APPLICATION FOR AMENDMENT TO PERMIT

Re: Preble, Inc.
20-22 Preble St.
Portland, Maine

Examination of application for permit and plan of alterations on the second floor at the rear of 477 Congress Street (over Preble Street entrance to Civic Theatre) to make there a dance studio and a major assembly hall, discloses the following deficient features as regards compliance with the Building Code:

Reliable Furniture Co. - 20-22 Preble St.

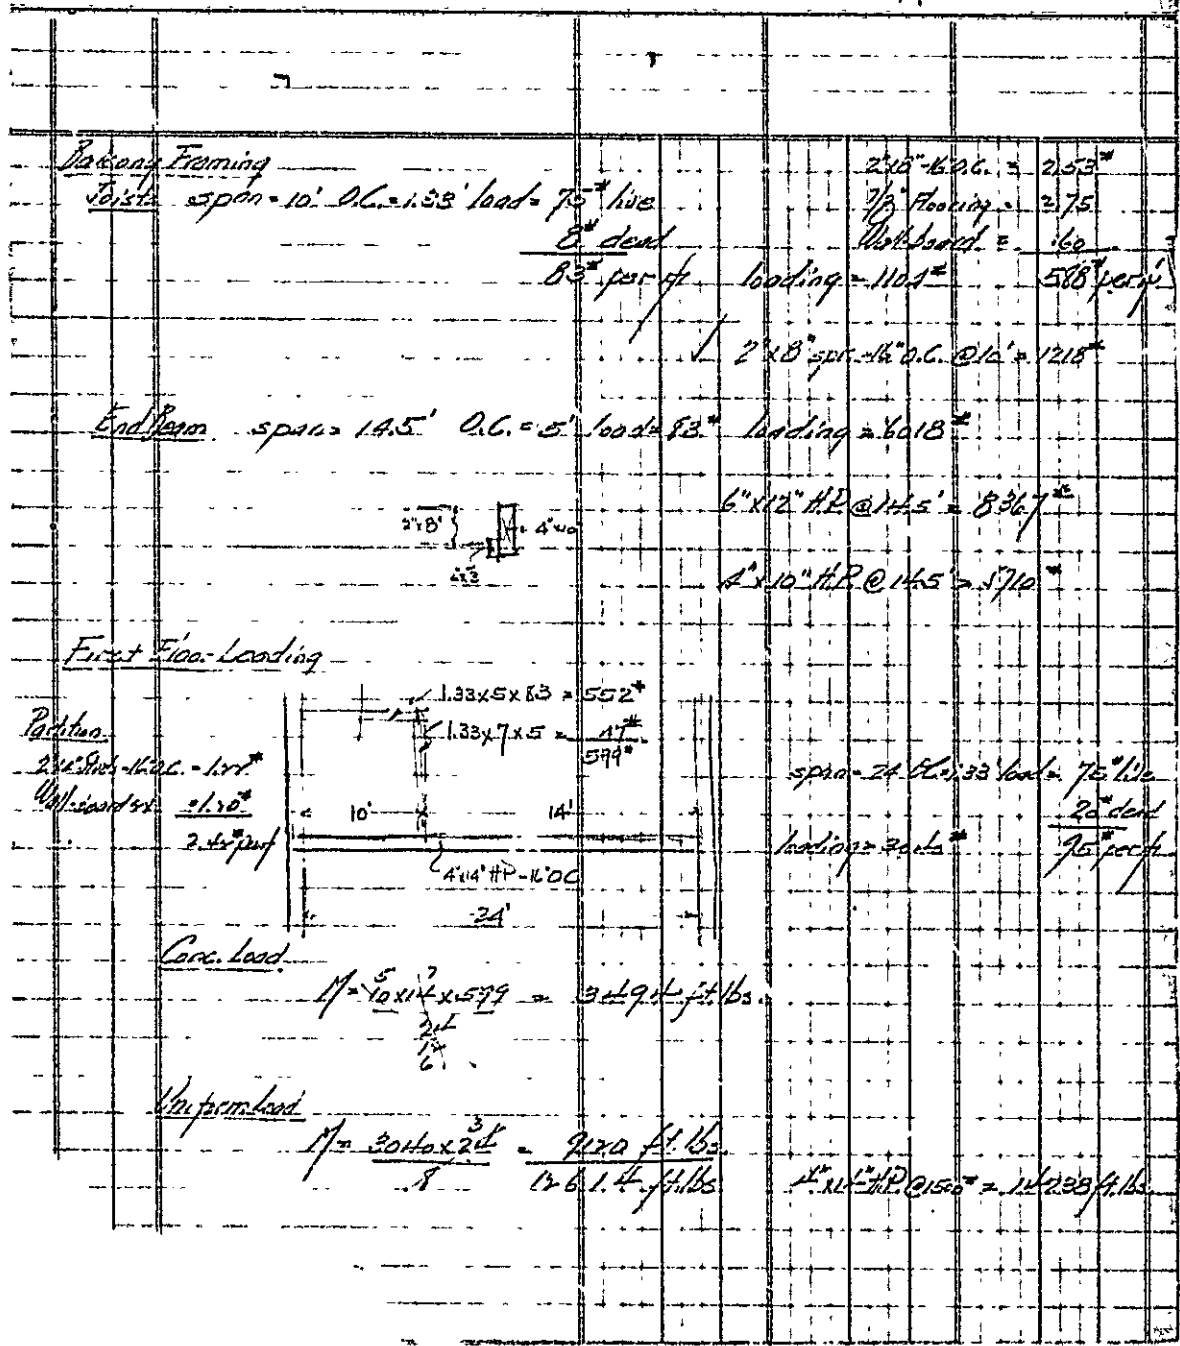
2x8 joist - 12" o.c good for on 14'-9" span
 $2 \times 5 \times 30 = 1060$

X $\frac{1060}{14.75} = 71.5 \text{ psf}$
